Addendum No. 1

RE: Contract # C204736

Guilford County (I-5955)

I-40 FROM BUFFALO CREEK BRIDGE EAST OF US-220 TO EAST OF SR-3037/SR-4240 (GATE CITY BLVD) IN GREENSBORO

BARRIER WALL SPECIAL NOTE:

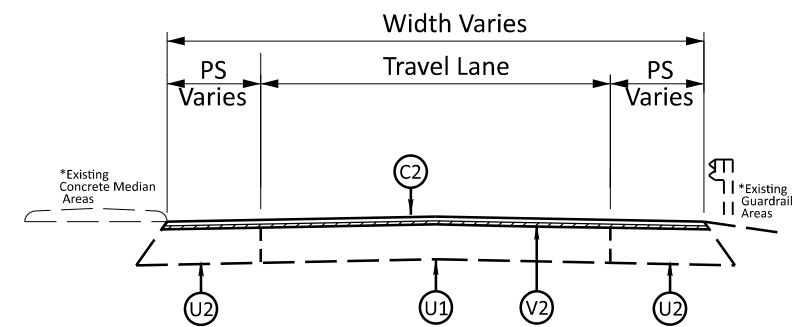
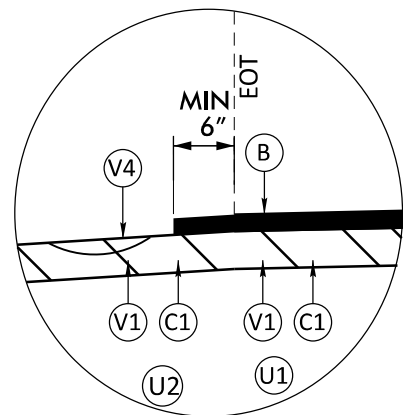
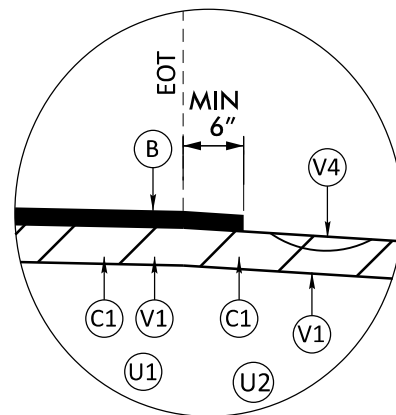
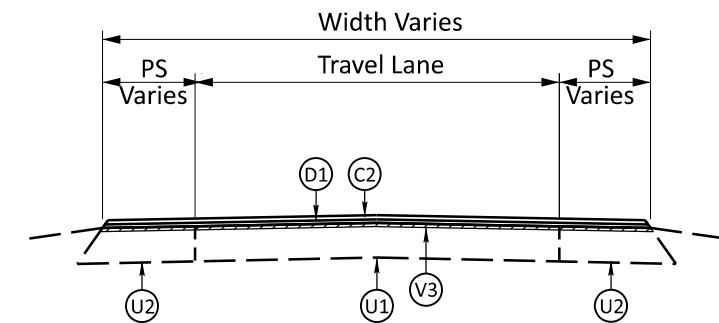
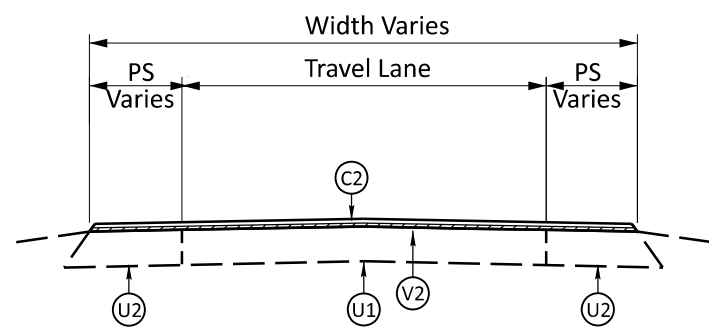
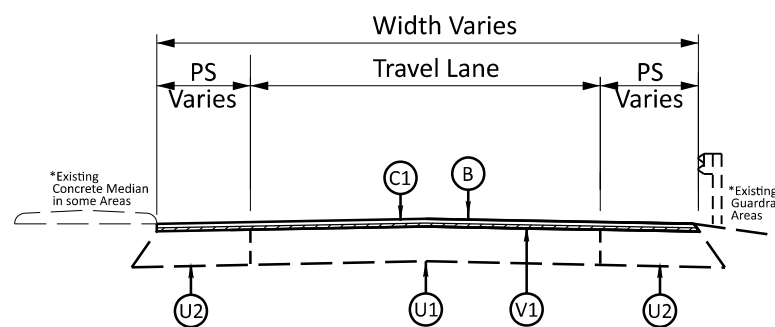
Sheet No.	Revision
3	Barrer Wall Special Note added.
7-8	Summary of Quantities updated to reflect new pay items.

1. CONTRACTOR TO MILL AS CLOSE TO INSIDE BARRIER WALL AS REASONABLY POSSIBLE.
2. LEAVING A MINIMUM STRIP OF MATERIAL AGAINST INSIDE BARRIER WALL IS ACCEPTABLE OR AS DIRECTED BY THE ENGINEER.
